## Historic Architectural Review Commission Staff Report for Item 5

**Application Number:** H17-03-0020

**Address:** #1119 South Street

Renovations to existing house. Two-story side and rear additions and new side pool.

2 PROPOSED STREETSCAPE - SOUTH STREET  
A12 SCALE: 1/8"=1'-0"

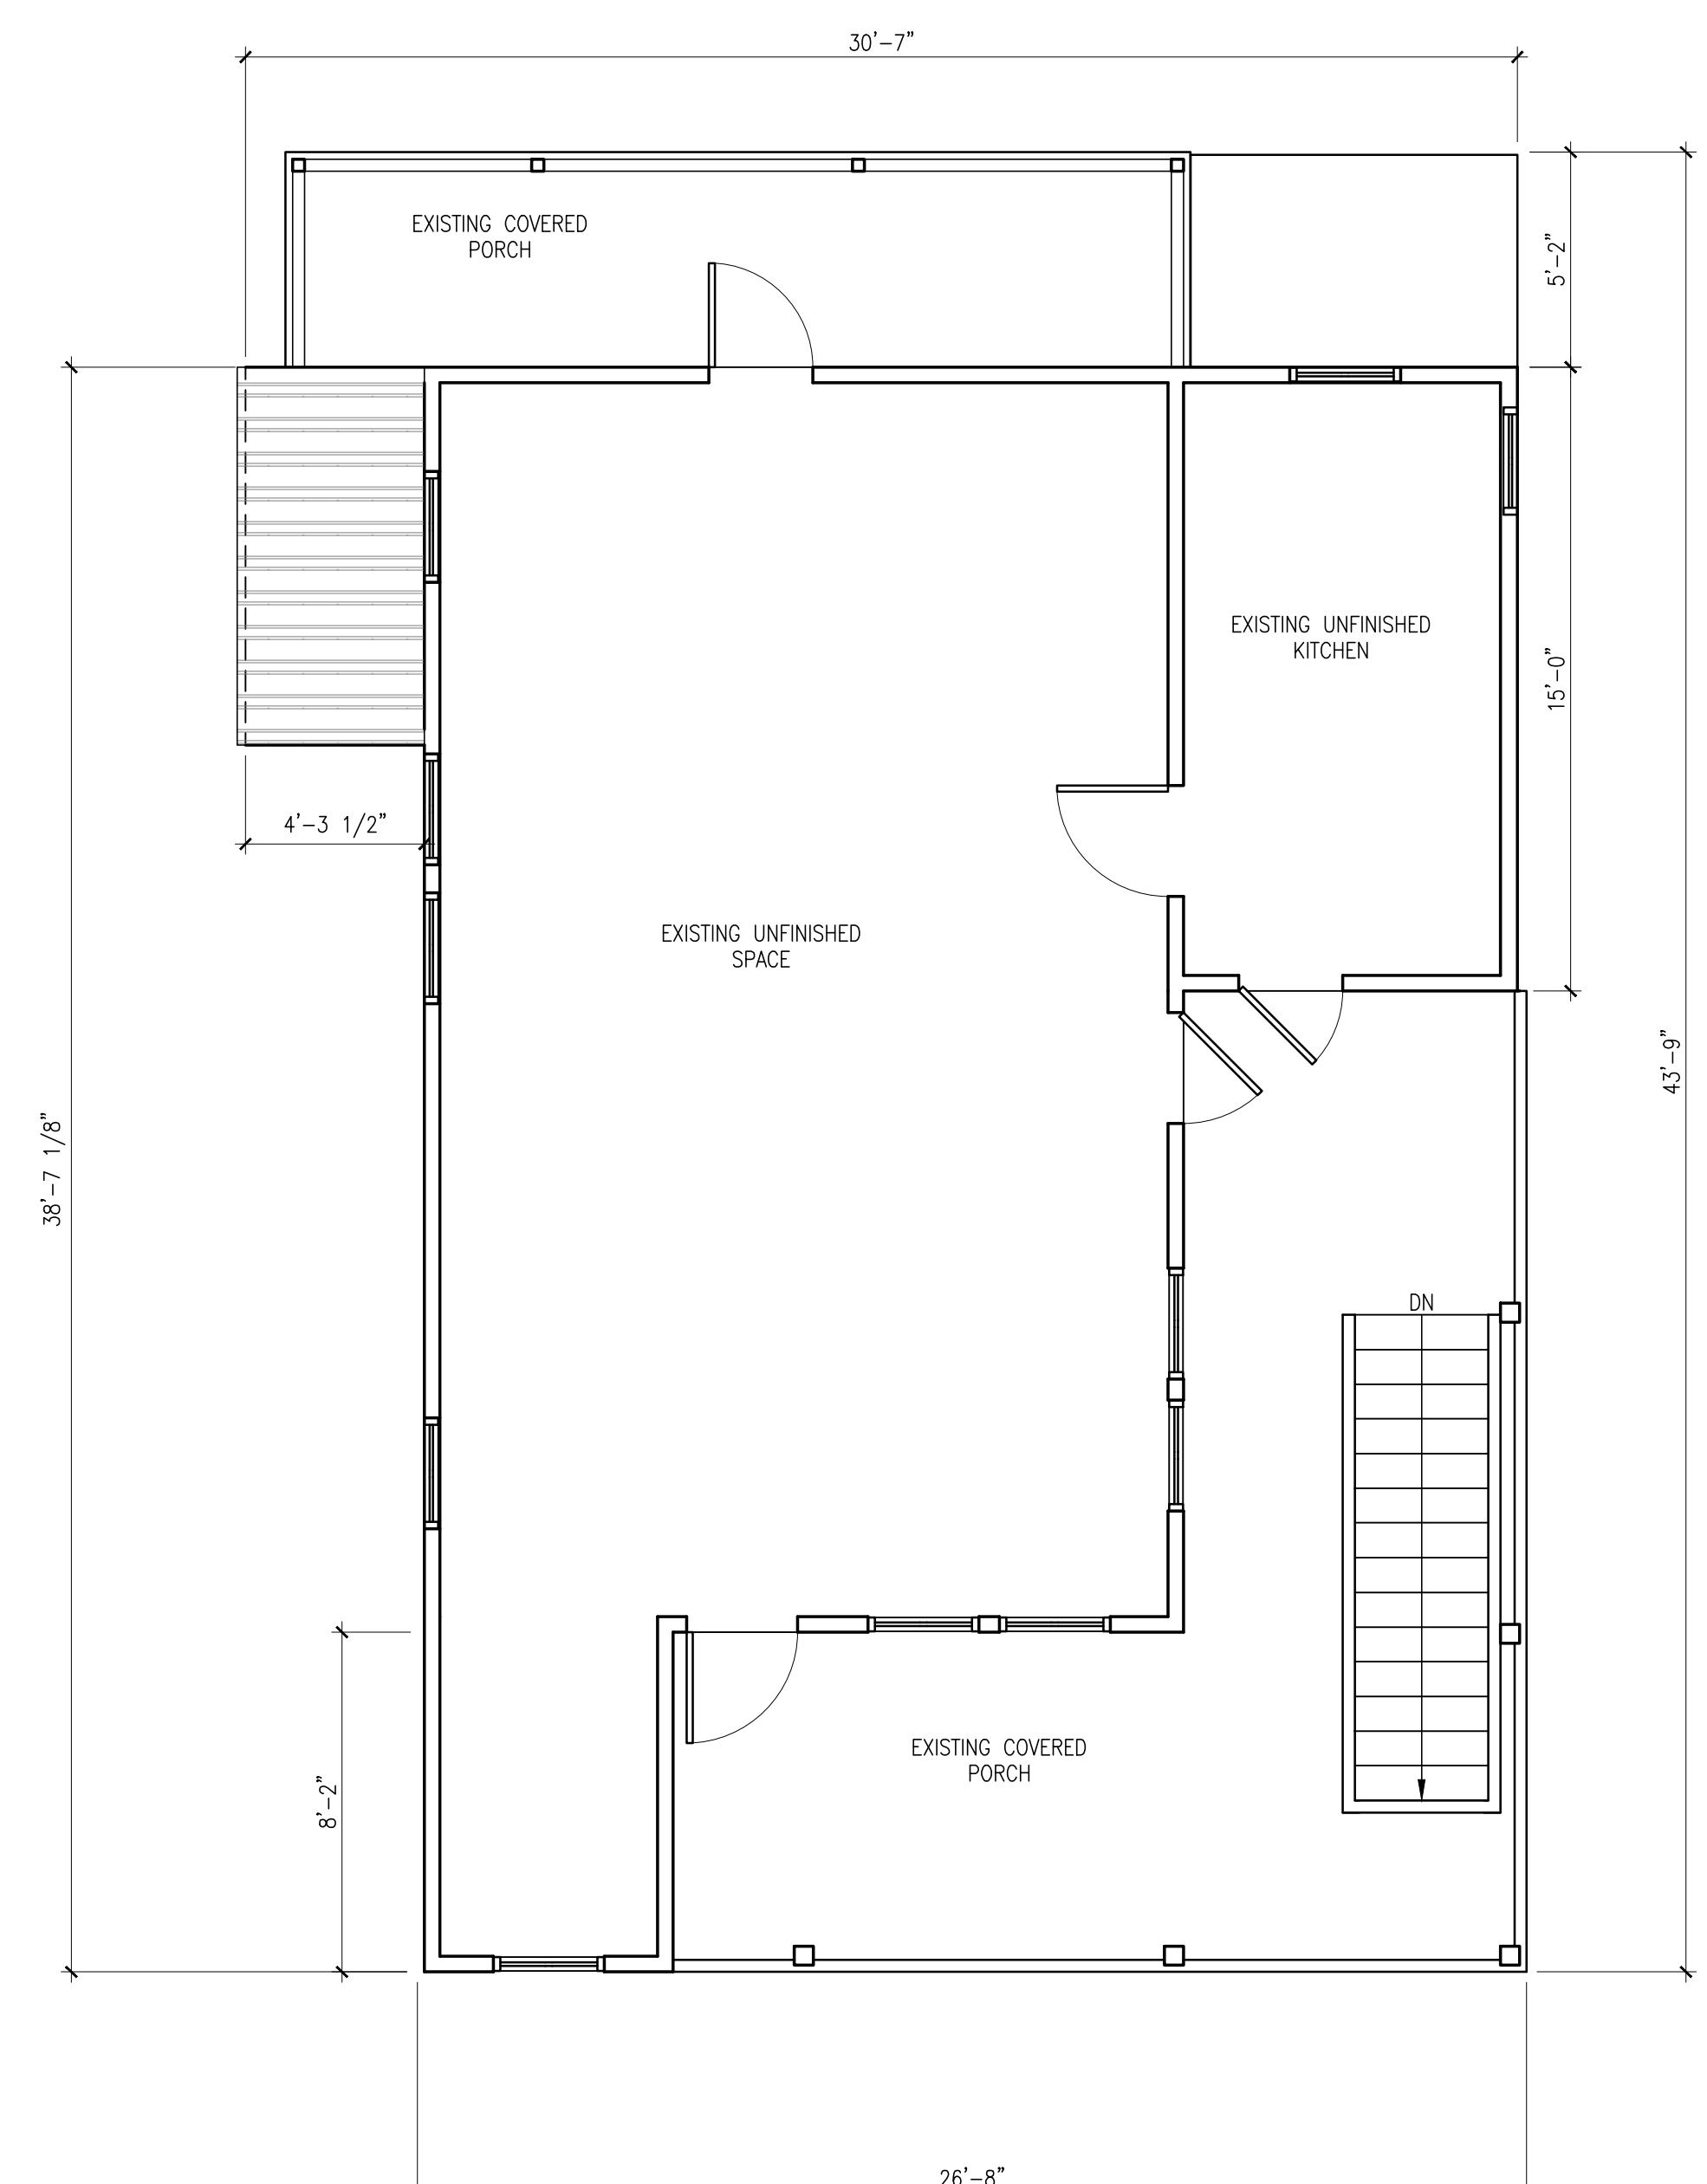
The adjacent property, 1117 South Street, is a contributing, one-story structure. The new west-side addition is a two-story addition that will be taller than 1117 South Street, but the addition will be set approximately 60 feet from the front property line. Still, staff believes that the western two-story addition could be reduced a bit in massing to lessen its impact on the historic structure and the neighboring contributing structure at 1117 South Street.

It is staff’s opinion that the proposed design mostly complies with the guidelines. The two-story addition proposed on the western side of the structure is large, and although it will be set back approximately 60 feet from the front property line, staff does believe that a reduction in width and height of the addition would lessen the addition’s impact on the historic house and the surrounding contributing structures.
